HISTORIC AND DESIGN REVIEW COMMISSION February 21, 2018

HDRC CASE NO: 2018-074

ADDRESS: 502 E MULBERRY AVE **LEGAL DESCRIPTION:** NCB 3090 BLK 6 LOT D

DISTRICT: Monte Vista Historic District **APPLICANT:** Bryan and Corey Wildman

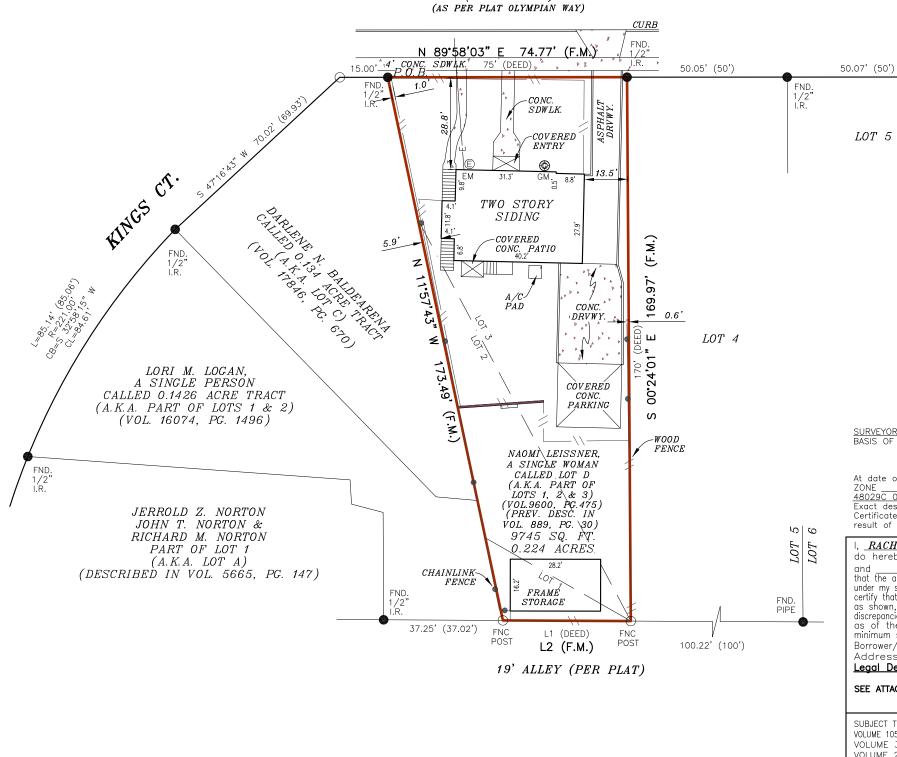
- h. SITE WORK The applicant has noted the installation of six rear yard parking locations. Per the site survey, the existing driveway width is 13′ 5″, which connects to an existing concrete driveway in the rear yard. Staff finds the location of proposed parking to be appropriate and consistent with the Guidelines for Site Elements 7.A.i.While the proposed parking location is appropriate, the Guidelines for Site Elements 3.B.i. notes that large impervious surfaces should not be introduced where they do not historically exist. Staff finds the installation of gravel, decomposed granite or another pervious surface is appropriate. Concrete should not be installed to cover the majority of the rear yard.

- iii. That a pervious material be installed at the rear yard parking locations.
- 4. Staff recommends approval of item #4 with the stipulation that existing materials be salvaged for future use on site.

REAR	R EL	EVATION	
SCALE : 1/4"=1	'-0"		
O 1 2	4	8	16 F

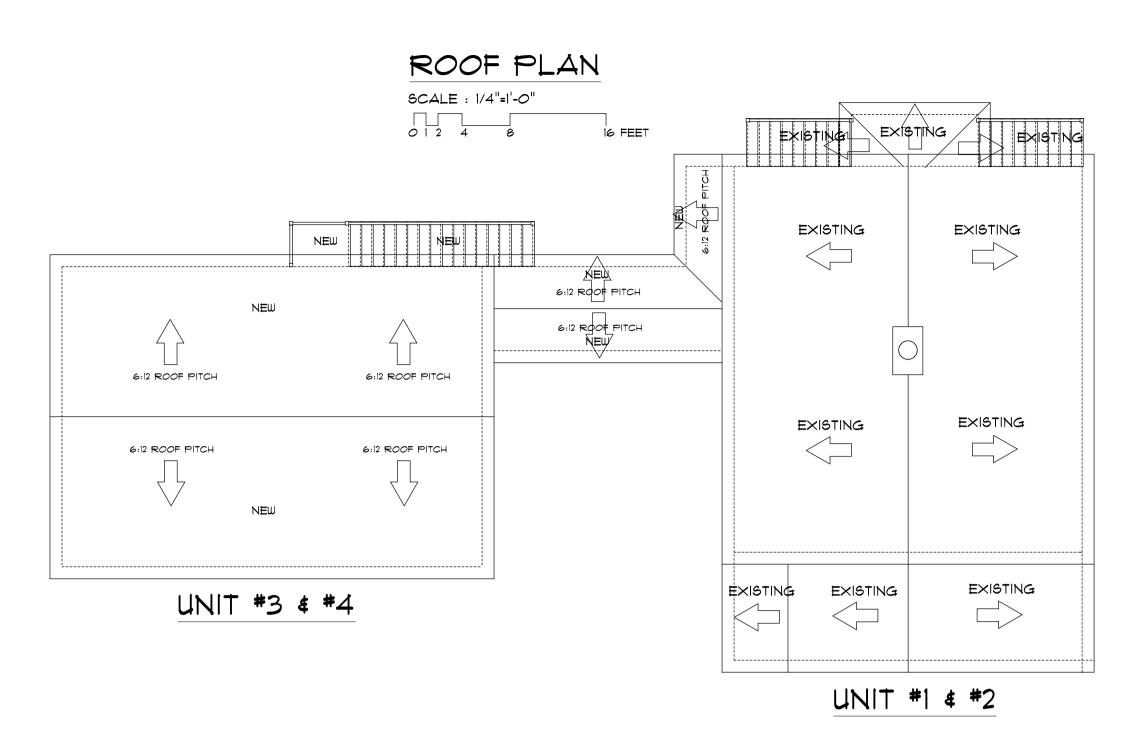
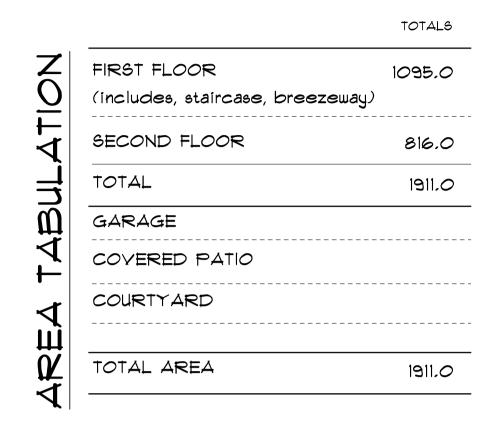
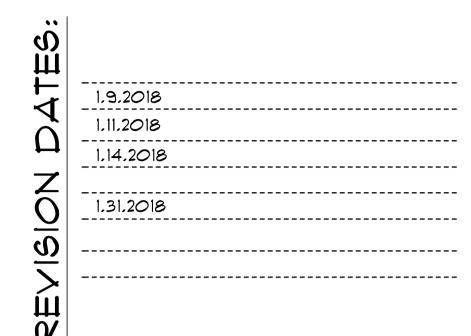
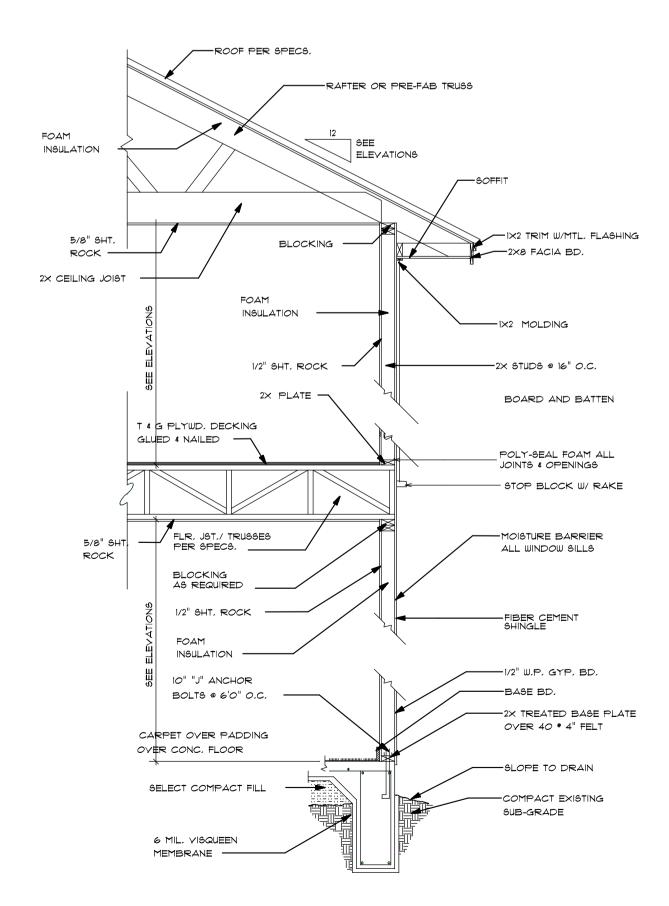
- e. MATERIALS The applicant has proposed materials for the addition that includes vertical and horizontally oriented Hardie siding, vinyl windows, an asphalt shingle roof and a wood staircase. Staff finds that all Hardie siding should feature a smooth finish. Horizontal siding used on the first floor should feature an exposure of four (4) inches. Vertical board and batten siding should feature boards that are twelve (12) inches wide with battens that are $1 \frac{1}{2}$ " wide. Staff finds wood stairs and the proposed asphalt shingle roofing appropriate and consistent with examples found in the district.

- f. WINDOW MATERIALS The applicant has proposed to install one over one, vinyl windows. Staff finds that wood or aluminum clad wood windows should be installed that feature meeting rails that are no taller than 1.25" and stiles no wider than 2.25". White manufacturer's color is not allowed, and color selection must be presented to staff. There should be a minimum of two inches in depth between the front face of the window trim and the front face of the top window sash. This must be accomplished by recessing the window sufficiently within the opening or with the installation of additional window trim to add thickness. Window trim must feature traditional dimensions and an architecturally appropriate sill detail. Window track components must be painted to match the window trim or concealed by a wood window screen set within the opening.

- g. ARCHITECTURAL DETAILS Generally, the proposed addition is appropriate for the style of the primary historic structure. Staff finds that the proposed fenestration patterns and trim details to be appropriate.

- i. That all Hardie siding feature a smooth finish. Horizontal siding used on the first floor should feature an exposure of four (4) inches. Vertical board and batten siding should feature boards that are twelve (12) inches wide with battens that are $1 \frac{1}{2}$ " wide as noted in finding e.

- ii. That wood or aluminum clad wood windows should be installed that feature meeting rails that are no taller than 1.25" and stiles no wider than 2.25". White manufacturer's color is not allowed, and color selection must be presented to staff. There should be a minimum of two inches in depth between the front face of the window trim and the front face of the top window sash. This must be accomplished by recessing the window sufficiently within the opening or with the installation of additional window trim to add thickness. Window trim must feature traditional dimensions and an architecturally appropriate sill detail. Window track components must be painted to match the window trim or concealed by a wood window screen set within the opening as noted in finding f.
